SAFETY EVALUATION BY THE OFFICE OF NUCLEAR REACTOR REGULATION

RELATED TO AMENDMENT NOS. 103 AND 67 TO FACILITY OPERATING

LIMERICK GENERATING STATION, UNITS 1 AND 2

DOCKET NOS. 50-352 AND 50-353

DRYWELL CHILLED WATER SYSTEM PENETRATIONS
(TYPICAL)

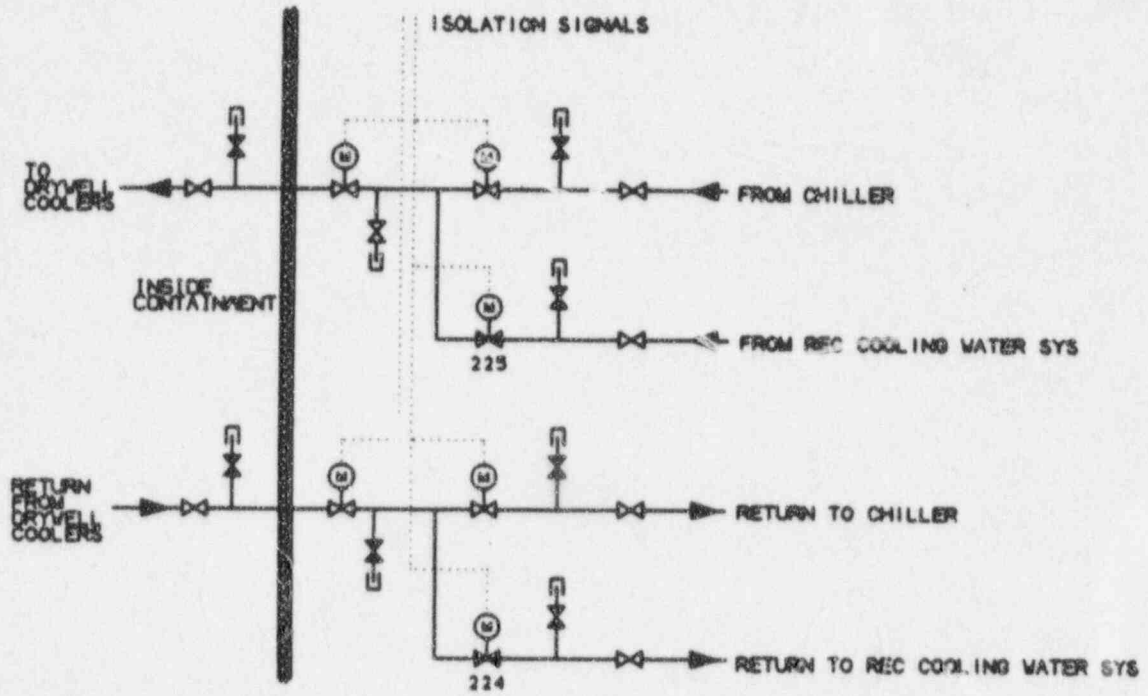
The valves identified as "224" and "225" in the attached drawing (four valves per unit) are classified as containment isolation valves and have maximum allowable closure time limits specified in the Technical Specifications for plant operations in Modes 1, 2 and 3. The licensee proposes to remove the automatic isolation relays for these valves and to lock the valve operator circuit breakers in the open position. The relays to be removed are devices which, when deenergized by an automatic isolation signal, cause the valve operators to close the valves if they are open. These modifications, along with administrative controls, will preclude the valves being open during Modes 1, 2 and 3. Thus the automatic closure feature will be unnecessary. The

valves will remain classified as isolation valves since they will still have a passive isolation function. The deenergization of the valve operator power source makes each valve a passive "sealed-closed barrier" as defined in Standard Review Plan Section 6.2.4, paragraph II.f. This eliminates the need for operability and surveillance testing of the automatic closure feature. The effect of locking open the valve operator circuit breakers removes the RECW system as a backup water supply. This is acceptable since both systems are non-safety. However, all aspects of Appendix J leak testing requirements of these two valves will remain in effect.

The licensee's modifications will eliminate the "active safety function to close" feature of the "224" and "225" valves. This feature can be eliminated because the RECW backup water supply to the DCWS system is not a safety requirement. As a result of eliminating the active isolation feature, the TS operability and surveillance requirements associated with automatic isolation are unnecessary. Therefore, based on the staff's review, the licensee's modifications are acceptable.
